COUNCIL ASSESSMENT PANEL MEETING

AGENDA – 9.1

Applicant: Damian Schultz	Landowner: S J Schultz
Agent: N/A	Originating Officer: Ashleigh Gade
Development Application:	20/894/473
Application Description: Demolition of existing dwelling and outbuilding & construction of replacement two storey detached dwelling, deck (maximum height 2.95m), retaining walls (maximum height 1.6m), fencing & associated earthworks (non-complying)	
Subject Land: Lot:91 Sec: P1022 FP:171040 CT:5324/817	General Location: 33 Yanagin Road Greenhill Attachment – Locality Plan
Development Plan Consolidated : 8 August 2019 Map AdHi/3	Zone/Policy Area: Hills Face Zone
Form of Development: Non-complying	Site Area: 1192m ²
Public Notice Category: Category 3 Non Complying Notice published in The Advertiser on 20 November 2020	Representations Received: 2 Representations to be Heard: 1

3.5.5 The ridgeline of 9.2m at the rear (North)

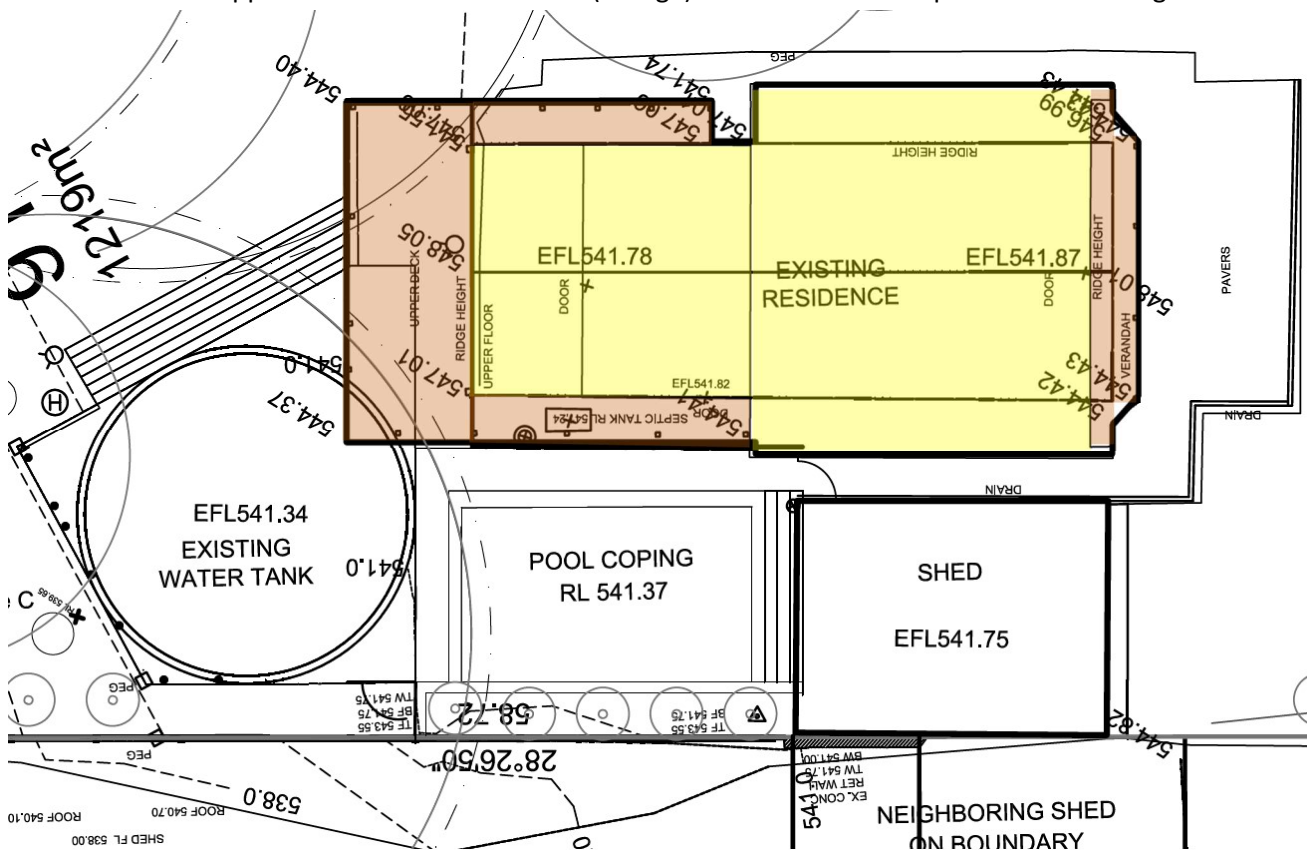
The ridgeline at the rear is over 10m high if the steps immediately adjacent to the north are included
